**Appeal Under the Town and Country
Planning Act 1990 (as amended) against
Decision of Refusal by Wrexham County
Borough Council**

**Land East of Bottom Road, Summerhill,
Wrexham**

PROOF OF EVIDENCE - HIGHWAYS

DRAWING No 1606405 REV D

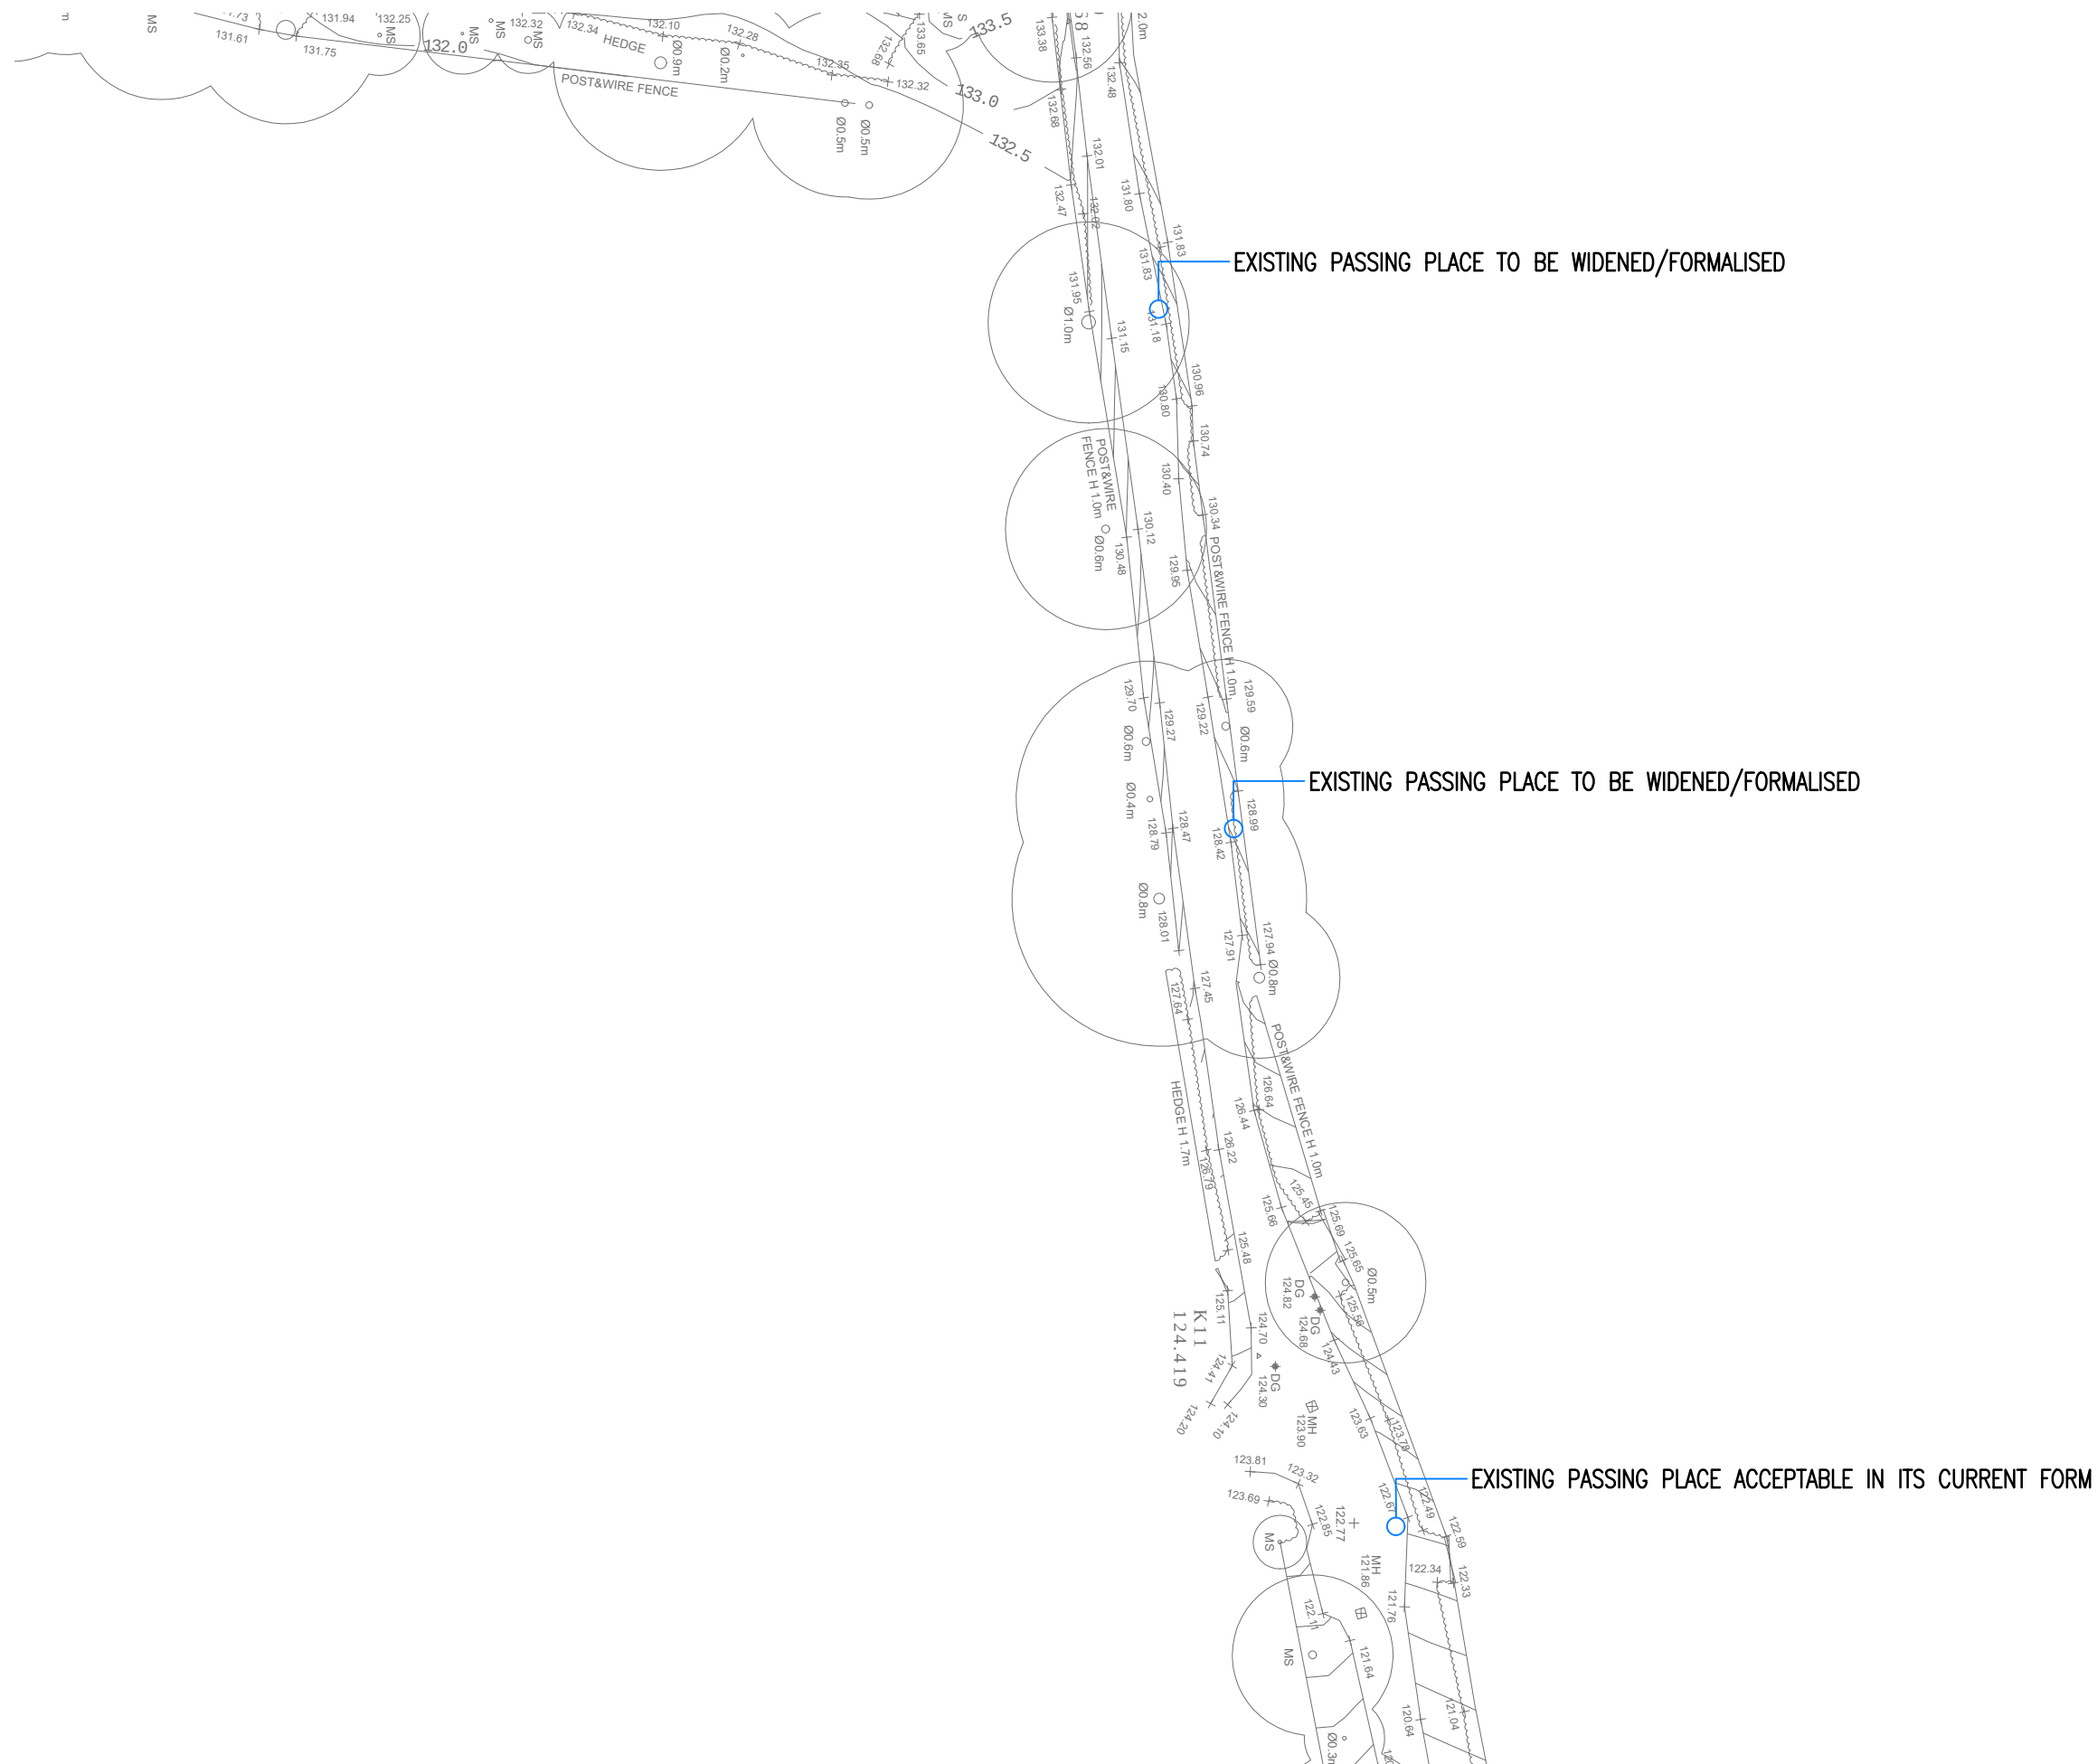
The proposed cycle link on plan 1606405 is over engineered. Given the width of the highway at this point it is highly likely that the link will be used as another passing bay and vehicles will ride over the foot/cycleway surface. Whilst consideration has to be given to improving cycle links I'm not convinced that this route is particularly suitable for encouraging the use of cycles.

FIGURE 11

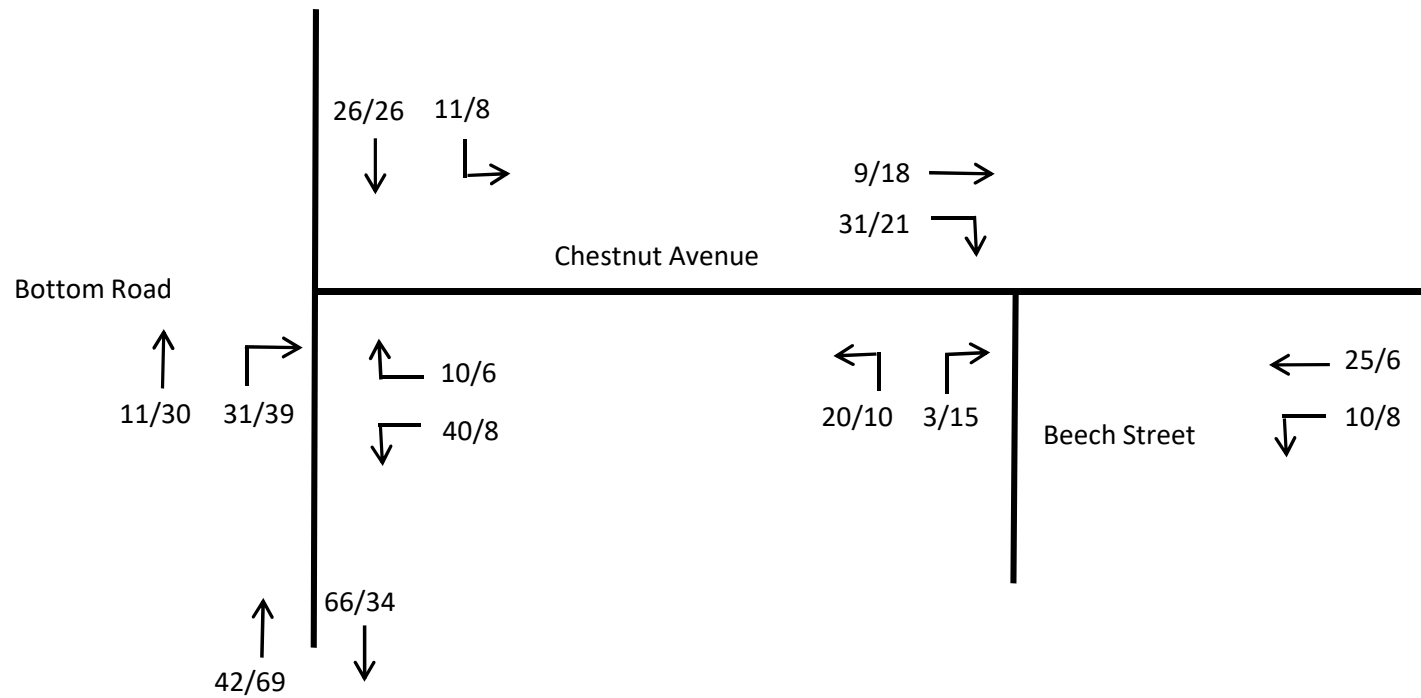
- 2.2.4. This view is substantiated by a further traffic survey that we commissioned before the same school holidays (referred to at paragraph 5.4.3 in our transport assessment) at the junctions of the "Old" Mold Road with Wheatsheaf Lane and with the A541 Mold Road. This shows that the two-way movement between Wheatsheaf Lane and the A541 to the north amounts to 433 and 509 vehicles in the AM and PM peak hours respectively. A flow diagram showing this information can be found in Figure 11 in Appendix D.

FIGURE 12

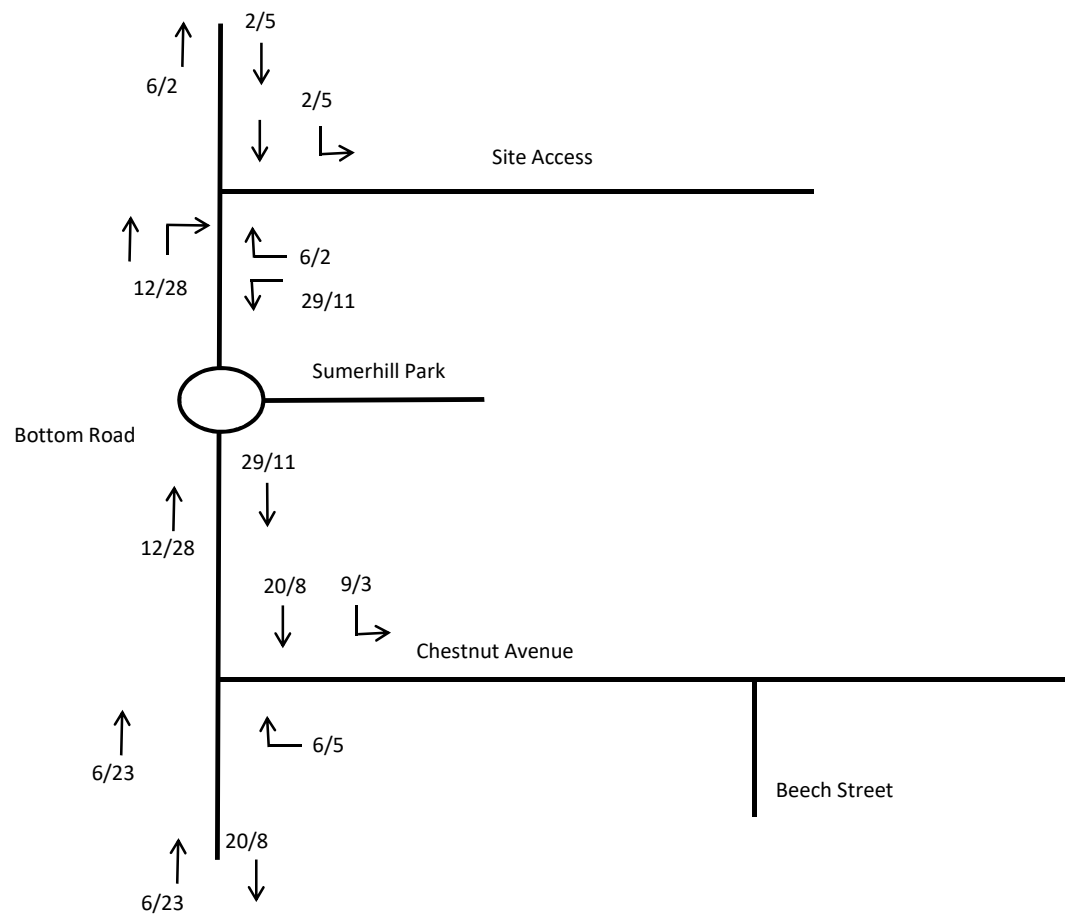
- 2.2.6. In order to further substantiate this point, a traffic survey was carried out at the junctions of Chestnut Avenue with Beech Street and Bottom Road in early July 2017 (during school term time). A flow diagram showing the AM and PM peak hourly turning flows can be found at Figure 12 in Appendix D of my evidence. This shows that of the 35 vehicles in the AM peak hour exiting the section of Chestnut Avenue east of Beech Street only 10 vehicles used the latter.

2.6.5. The survey carried out in early July 2017 (see Figure 12 in Appendix D) showed that the two-way flows on Bottom Road just north of its junction with Chestnut Avenue were recorded as being 58 and 70 vehicles in the AM and PM peaks respectively. The addition of development traffic would increase these flows to 99 and 109 vehicles per hour respectively (see Figures 12 and 13 in Appendix D). At less than 2 vehicles per minute the traffic volumes on this section of Bottom Road will continue to remain low post development.

SCALE: 1:1000 @A3
DATE: AUG 2017
DRAWING No: 1709801

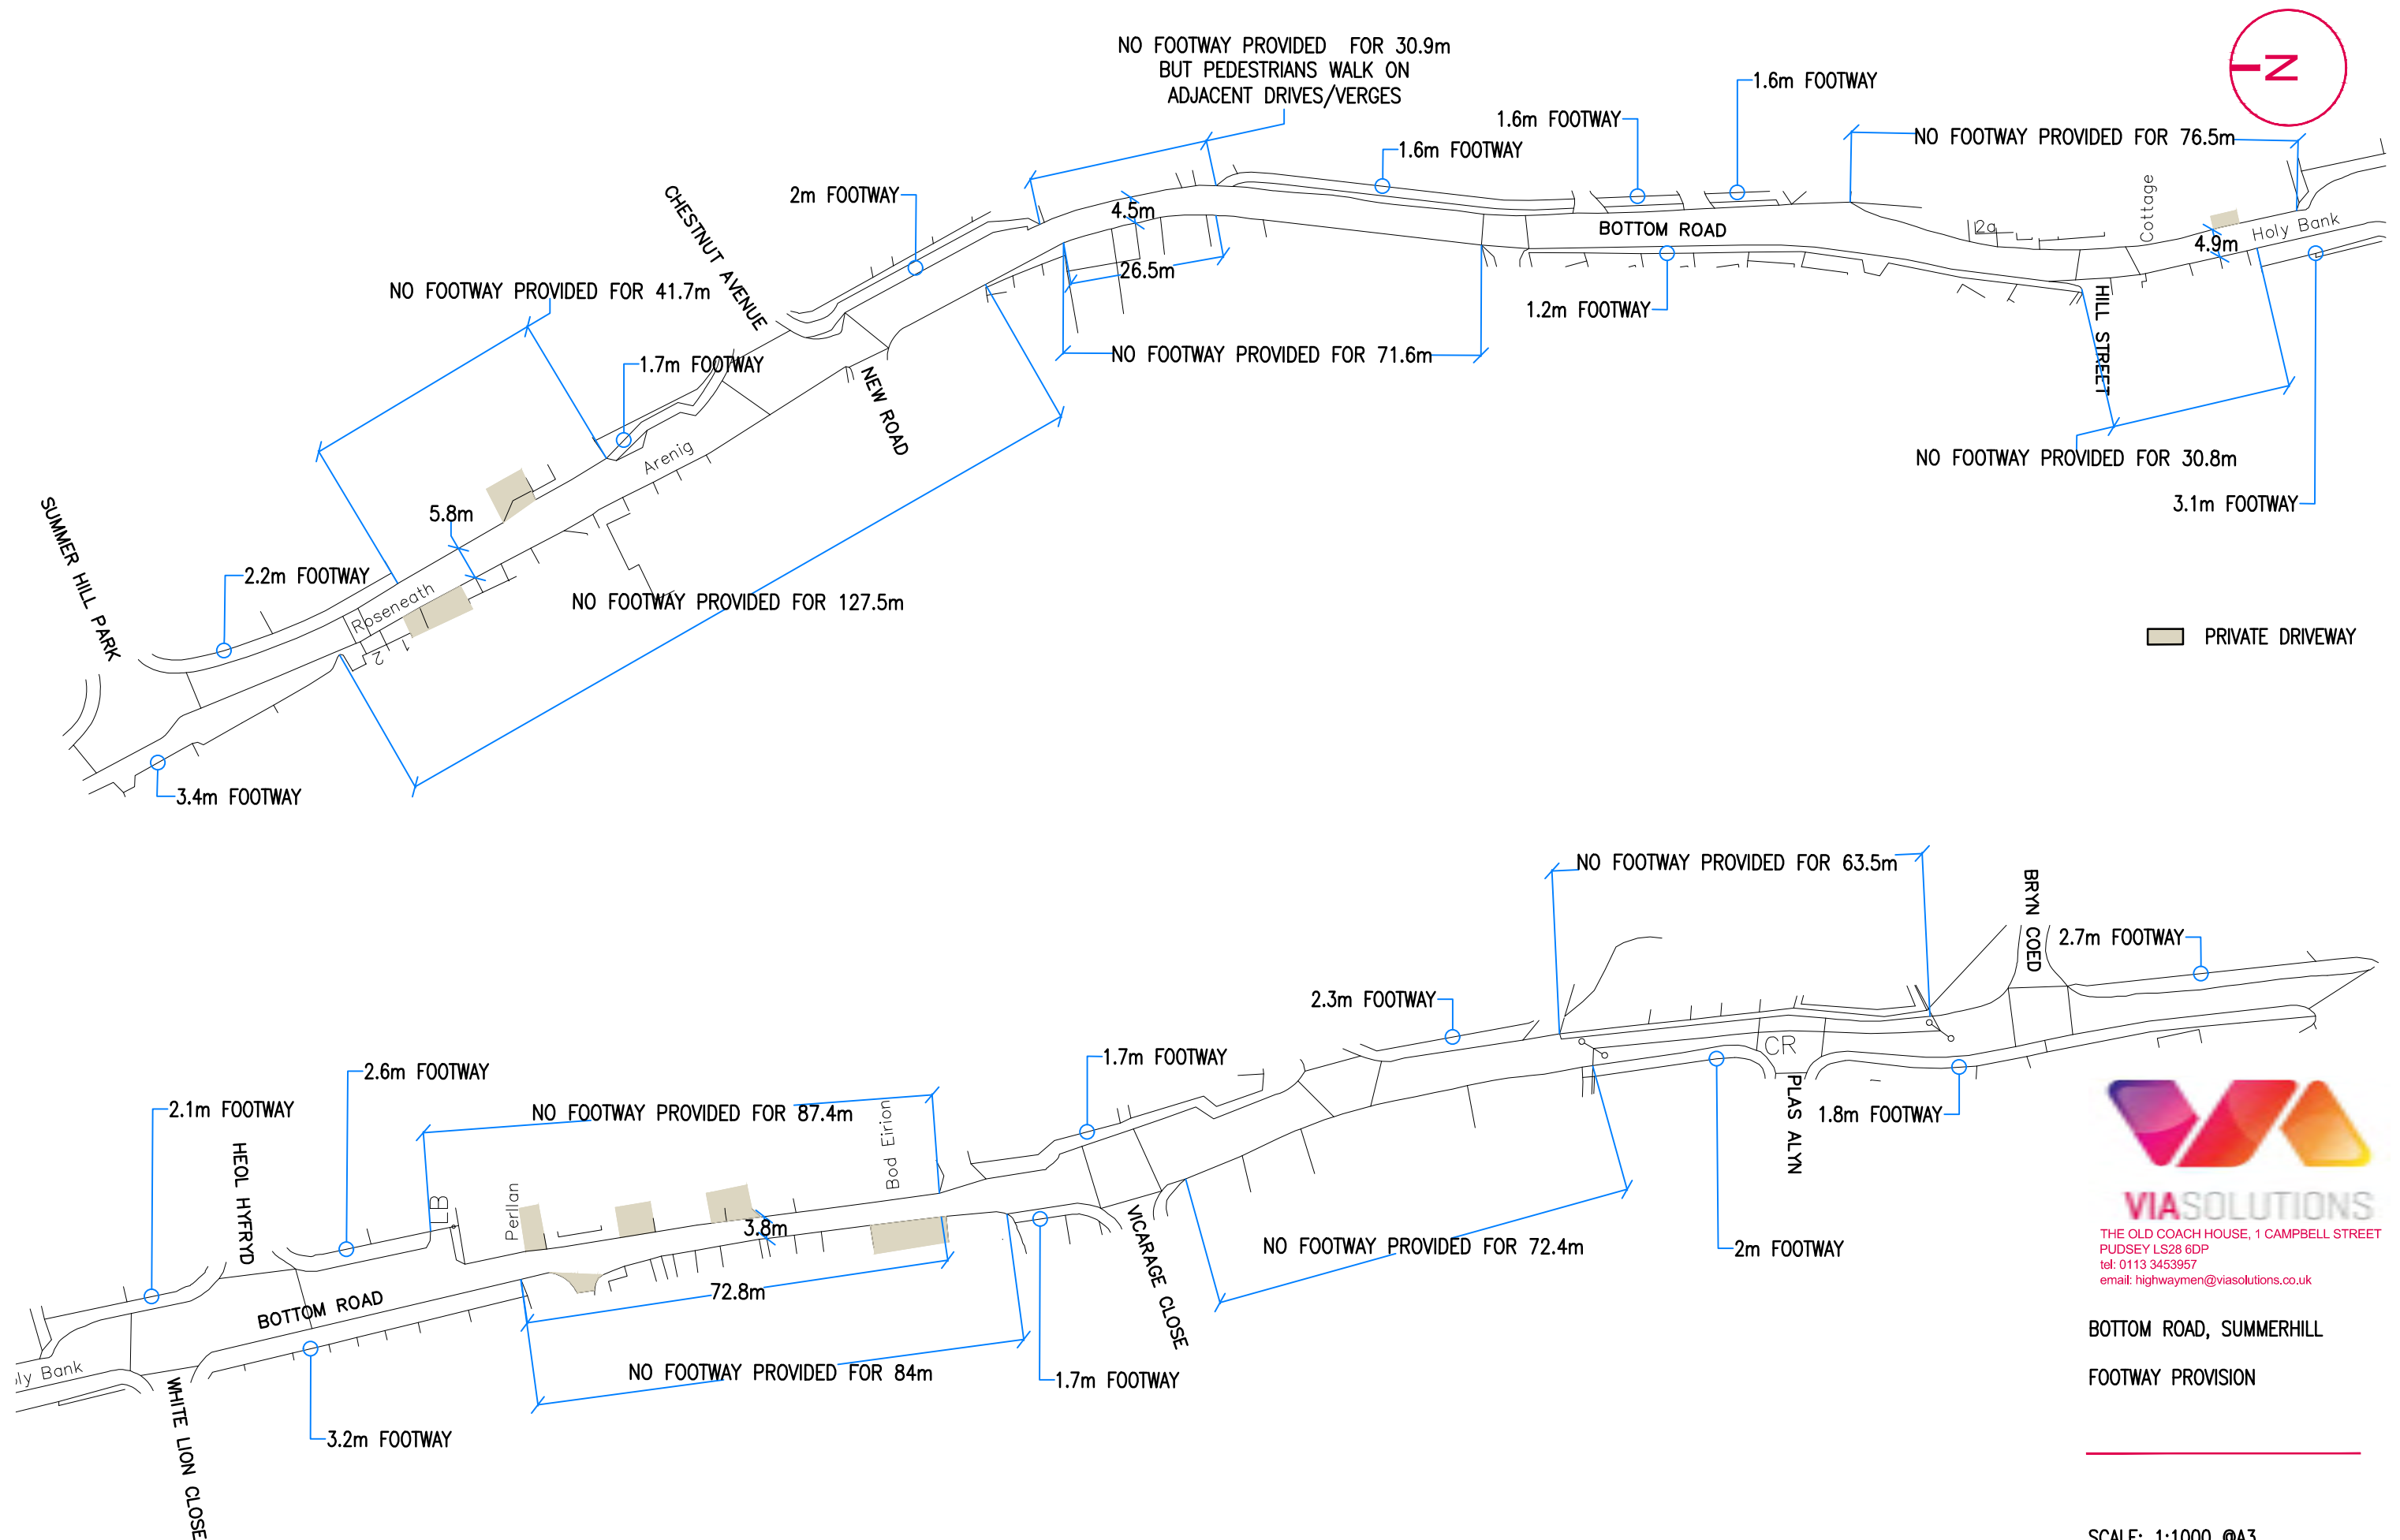
- 2.7.11. A plan has been prepared (1709801) which is attached at Appendix G of my evidence. This shows where there is footway provision on one or both sides of Bottom Road or none at all. The plan also gives an indication of the "standard" of the carriageway and footway provision along the highway.

- 2.7.12. The plan in Appendix G also shows areas where hard surfacing / driveways are located and which provide opportunities where a pedestrian can wait safely for a gap in traffic to proceed.

- 2.7.14. The plan shows on the section of Bottom Road between the Summer Hill Park and Chestnut Avenue junctions the carriageway narrows to 5.8m in width where there is a section with no footways of 41.7m. Two wider areas / driveways reduce the length shared between pedestrians and vehicles to two sections of 11.6m and 14.0m.
